Planning Approval Environmental Review Form

Assessment Name:	Canterbury footbridge
Prepared by:	Sydney Metro
Prepared for:	Sydney Metro and JHLOR
Assessment number	TfNSW 87
Type of assessment:	Assessment under EP&A Act 1979, Division 5.2
Version:	Final (1.0)
Planning approval No. (where relevant):	SSI 8256
Date required:	October 2024
iCentral number	SM-24-00284871

SWM3 – CANTERBURY STATION FOOTBRIDGE – HERITAGE ADVICE

SYDNEY METRO CITY & SOUTHWEST CANTERBURY STATION (ZONE ... 10.596km to 10.930km) SOUTHWEST METRO CONVERSION AND STATION WORKS STRUCTURAL UPDATES
CONCOURSE FOOTBRIDGE - DEMOLITION & TEMPORARY BRACING PLANS

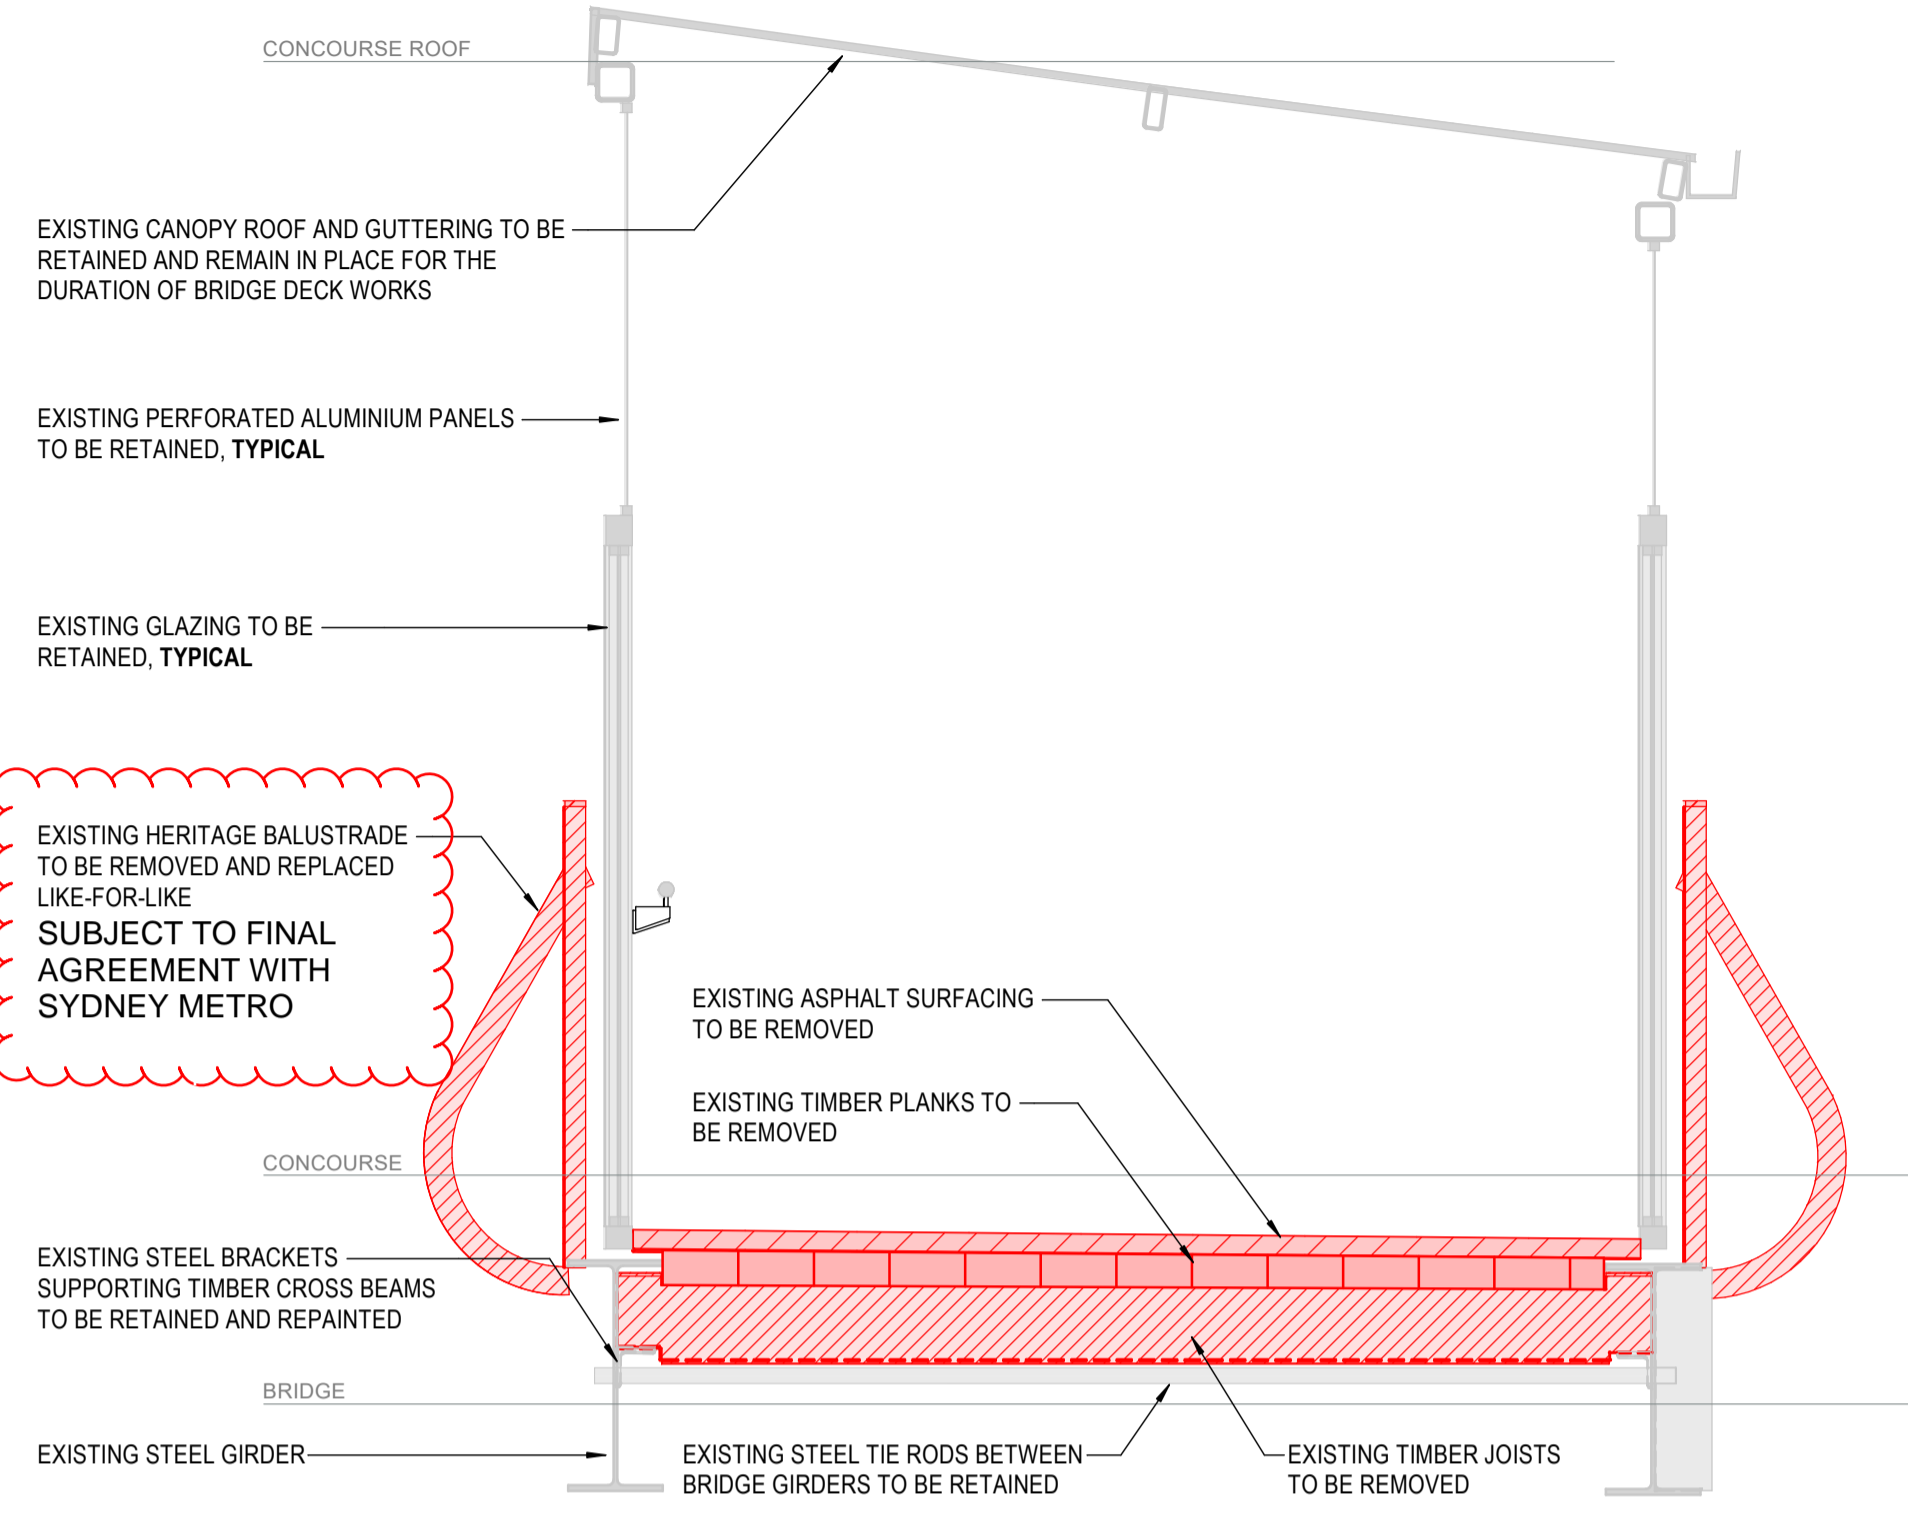
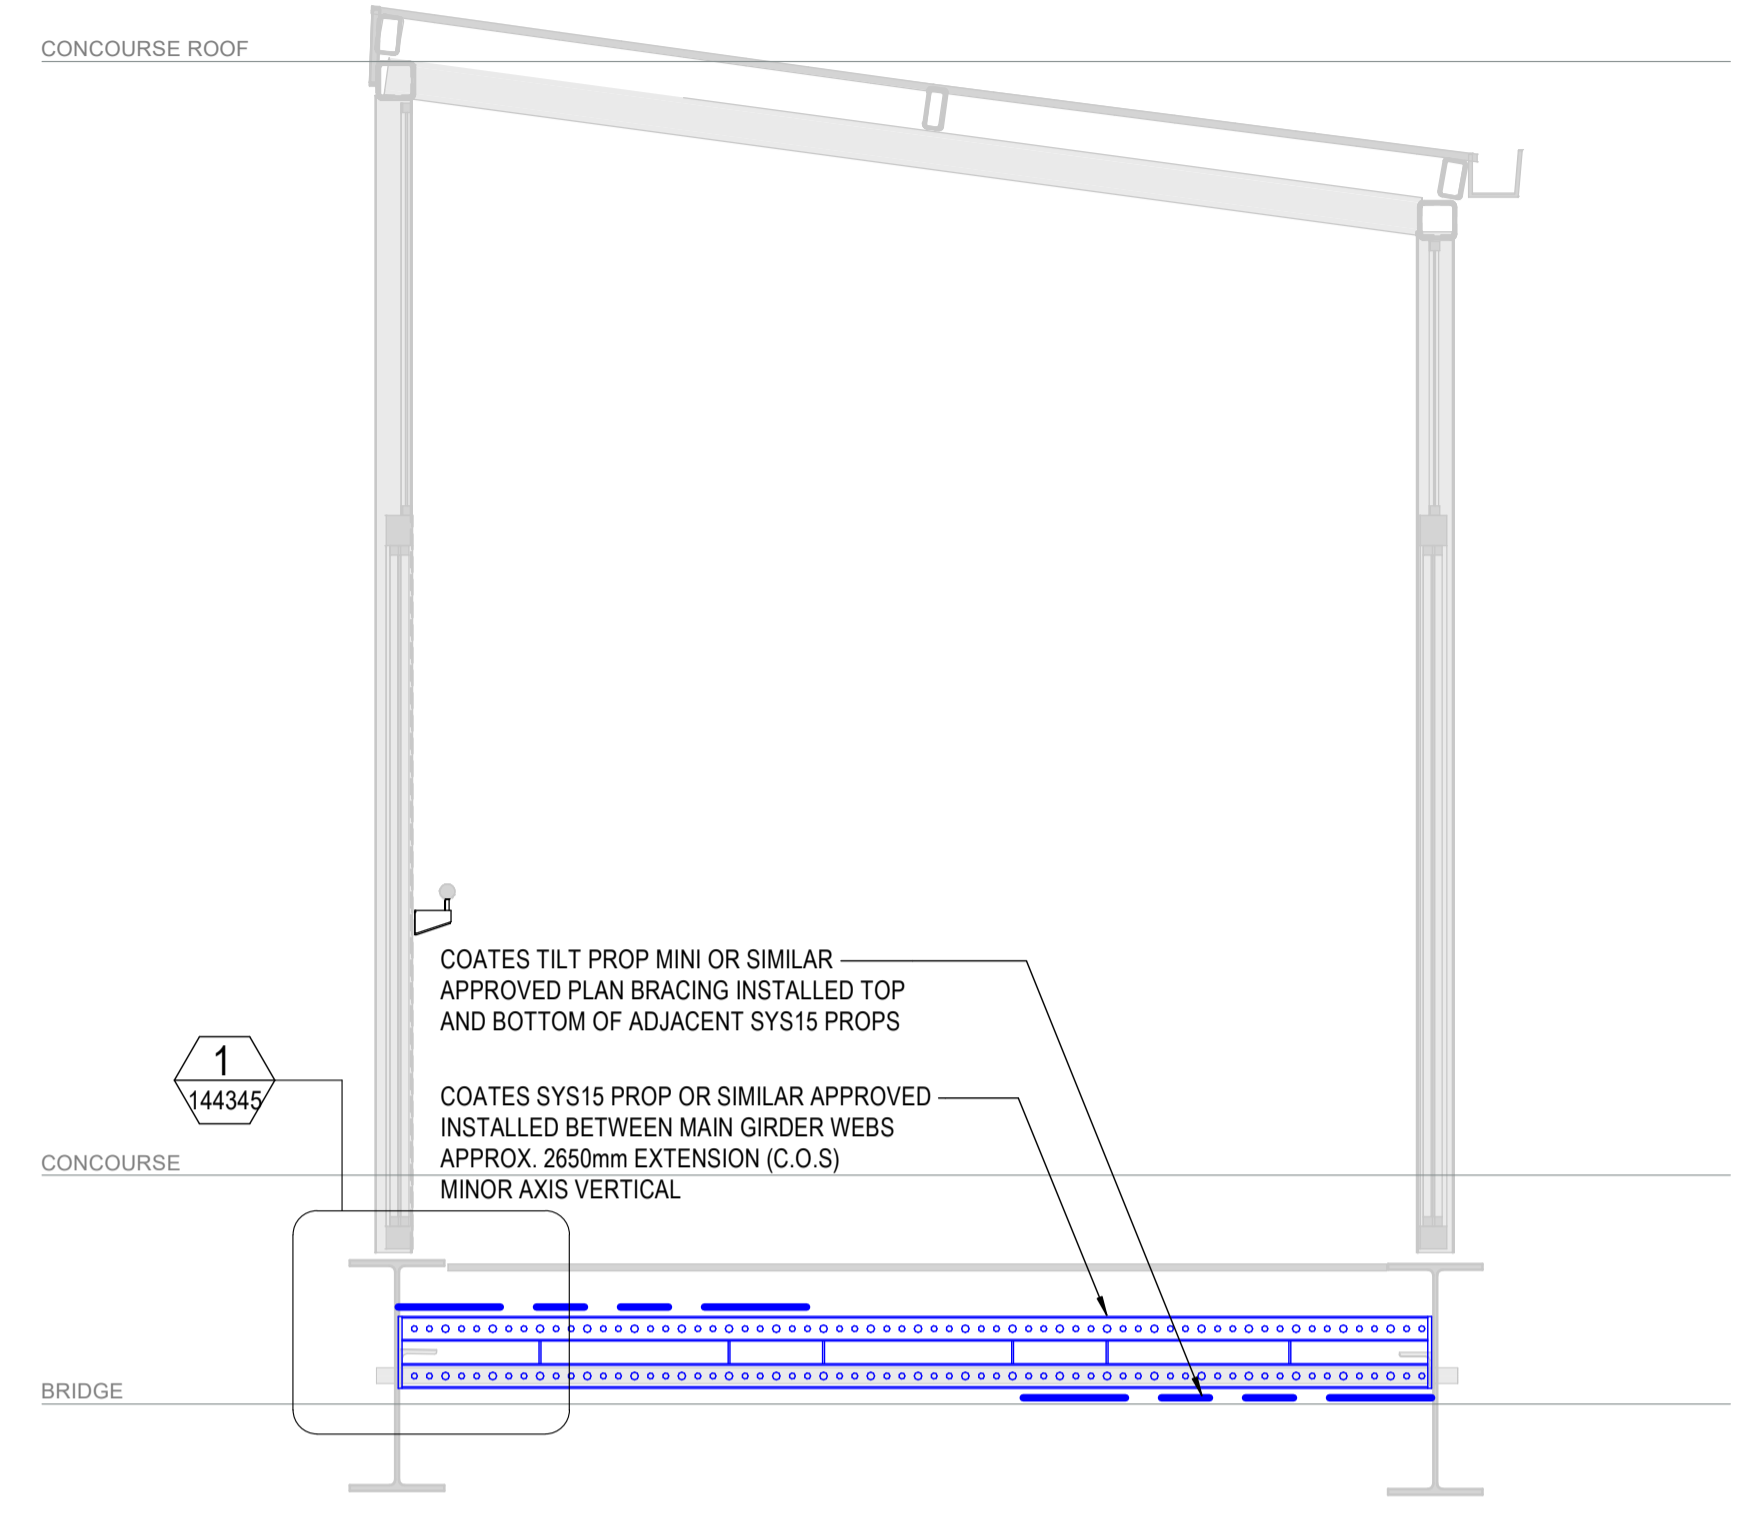
This Environmental Review assesses potential impacts associated with the proposed works to the Footbridge, including potential permanent removal of the balustrade and removal of the timber decking.

Justification for works	<p>Removing the existing timber decking of the Footbridge and re-decking is required to ensure structural compliance of the future pedestrian walkway. Over time the timber has deteriorated and is therefore not safe to use as a future walkway. Additionally the timber would need to be disposed of as it cannot be reused as part of the footbridge.</p>

<p>There is potential that the steel balustrades may need to be removed permanently to ensure maintenance of the future pedestrian walkway. If possible, the Balustrades would be reinstated, where possible, or replaced like-for-like.</p>
<p>Timeframe for works</p>	<p>The works are proposed to commence early October 2024 for about a month.</p>
<p>Work hours, workforce and equipment / machinery</p>	<p>Work hours: Standard Construction hours</p> <ul style="list-style-type: none"> Monday to Friday 7am-6pm Saturday 8am-6pm No works on Sunday or Public Holidays <p>Workforce: 8-16 pending staged works</p> <p>Equipment/Machinery: Hand and powered tools, Hook trucks (load out), scaffolding,</p>

1. All works will be carried out in accordance with the Sydney Metro Sydenham to Bankstown EIS, SPIR and the Project Conditions of Approval.
2. All works will be carried out in accordance with the approved Construction Environmental Management Plan and any relevant sub plans.
3. It is recommended that the existing balustrade is reinstated, if possible, or replaced like-for-like as a second preference. If the existing balustrade cannot be reinstated the reasoning must be clearly documented and agreed with Sydney Metro.
4. The removed balustrade sections should be stored on site and labelled accordingly to enable its future reinstatement, where possible.
